AGENDA
MANOR PLANNING AND ZONING COMMISSION
105 E. EGGLESTON ST.
MANOR, TEXAS 78653
JULY 8, 2015, 6:30 P.M.

Re: First Construction Plan and Final Plat Review for
Shadowglen Phase 2, Section 20 Subdivision
City of Manor, Texas

Re: Stonewater Subdivision Phase 5
First Final Plat Application Submittal
City of Manor

Re: Stonewater Subdivision Phase 7
First Final Plat Application Submittal
City of Manor

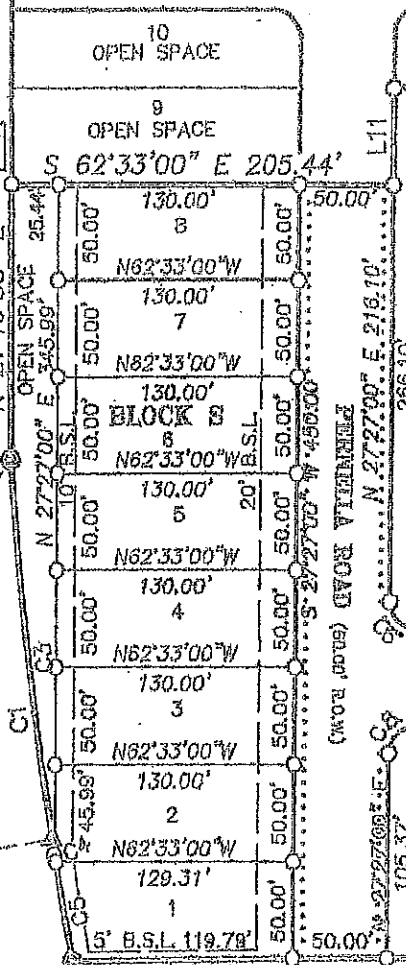
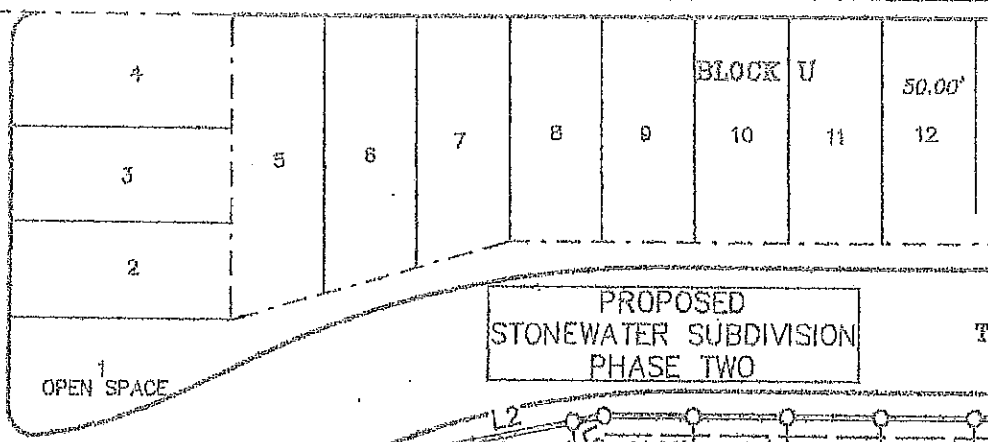
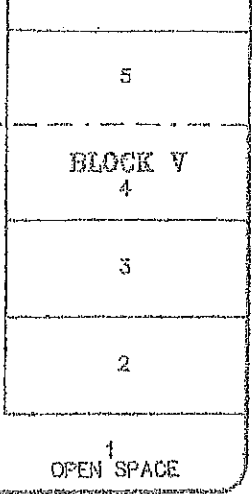
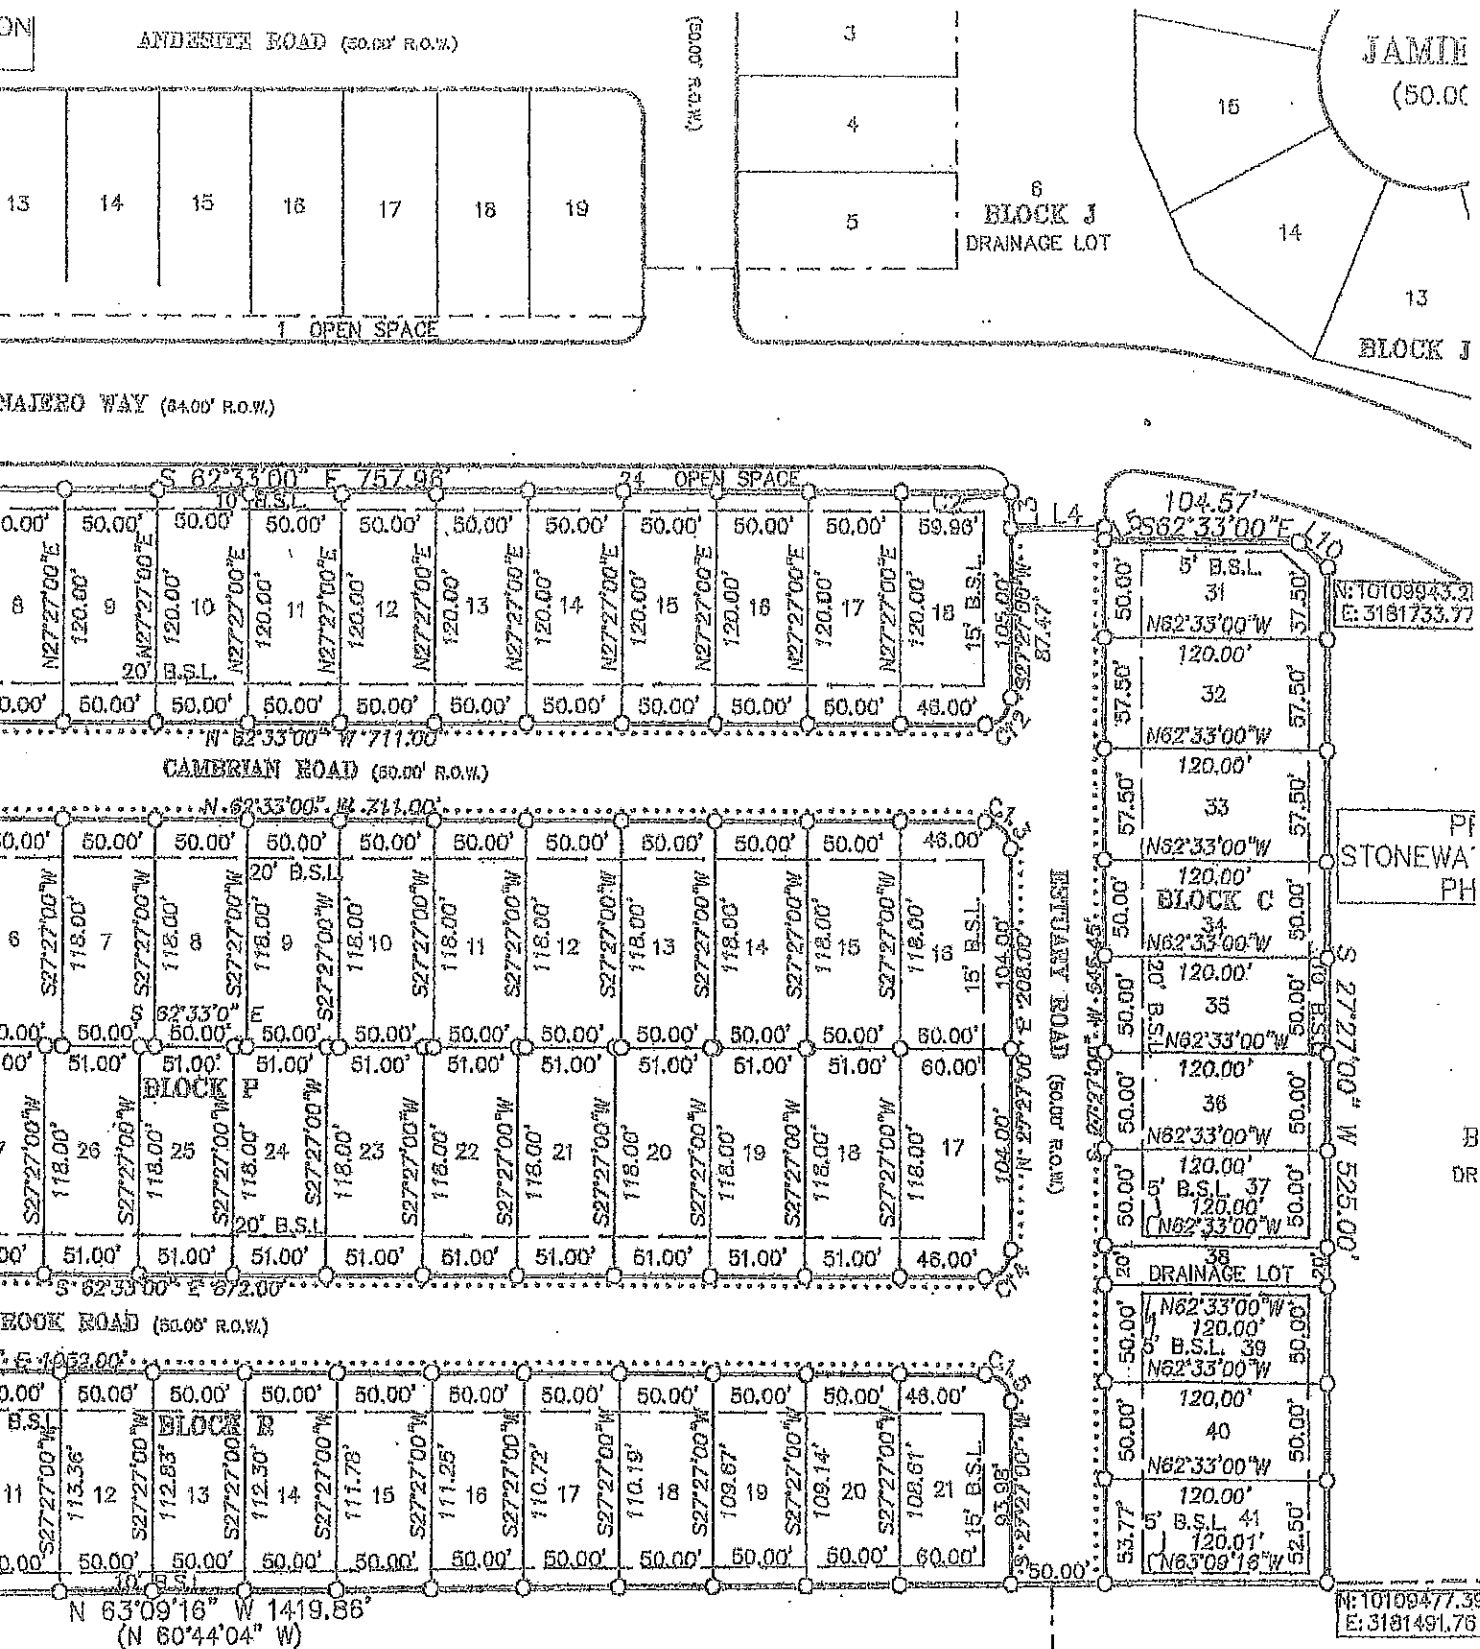
5. Plat does not include the city limits line as required in Section 24(c)(2)(iv) of Subdivision Ordinance 263 B. Location of City limit lines and/or outer border of the City's extra-territorial jurisdiction, as depicted on the City's most recent base map, if either such line traverses the subdivision or is contiguous to the subdivision boundary must be shown on the plat.

6. The open space lot along FM973 is not numbered as required in Section 24(c)(4)(iv) of Subdivision 263 B. The property lines and number designations of all proposed lots and blocks, with complete bearings, distances and dimensions for front, rear and side lot lines must be shown on the plat.

Response: Plat now includes the City of Manor ETJ line as shown on sheet 02.

Response: The open space lot along FM973 has been numbered to 11 on Block S as shown on sheet 02.

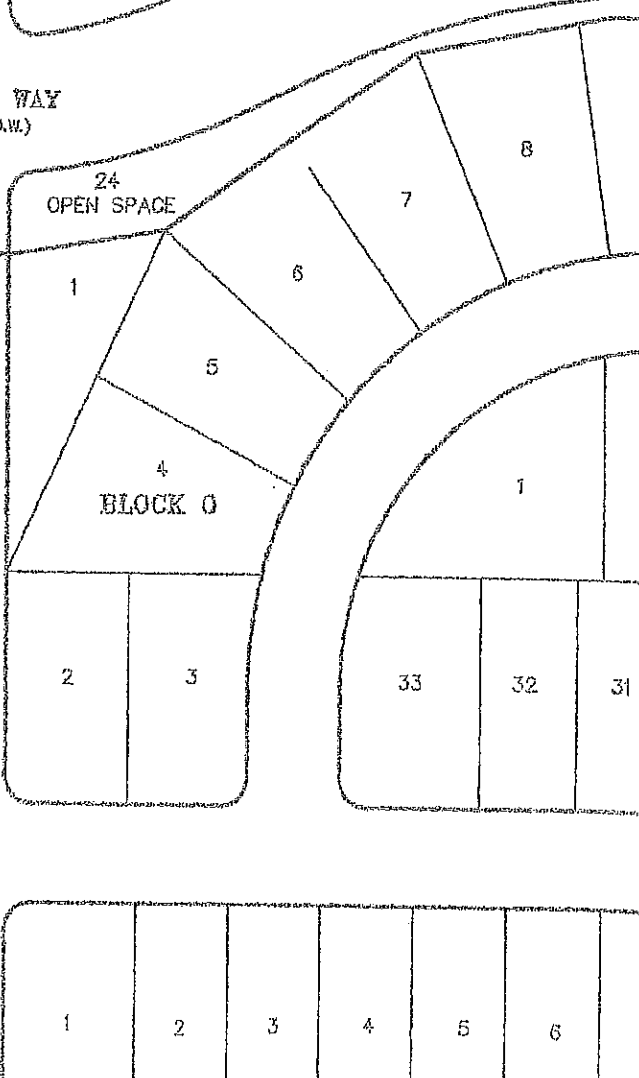
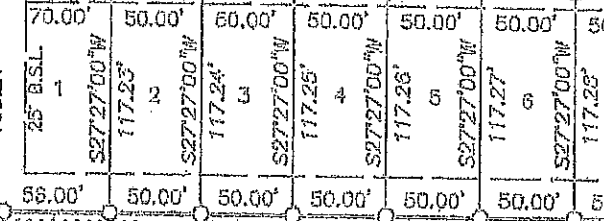
6. The drainage lot on Esker Road is not numbered as required by Section 24(c)(4)(iv) of Subdivision Ordinance 263 B. The property lines and number designations of all proposed lots and blocks, with complete bearings, distances and dimensions for front, rear and side lot lines must be shown on the plat.

7. The open space lot within the block is not designated and numbered as required by Section 24(c)(4)(iv) of Subdivision 263 B. The property lines and number designations of all proposed lots and blocks, with complete bearings, distances and dimensions for front, rear and side lot lines must be shown on the plat.

Response: The drainage lot on Esker Road has been numbered 6 in Block J as shown on sheet 02.

Response: The open space lot within the block has been numbered to 9 of Block V as shown on sheet 02.
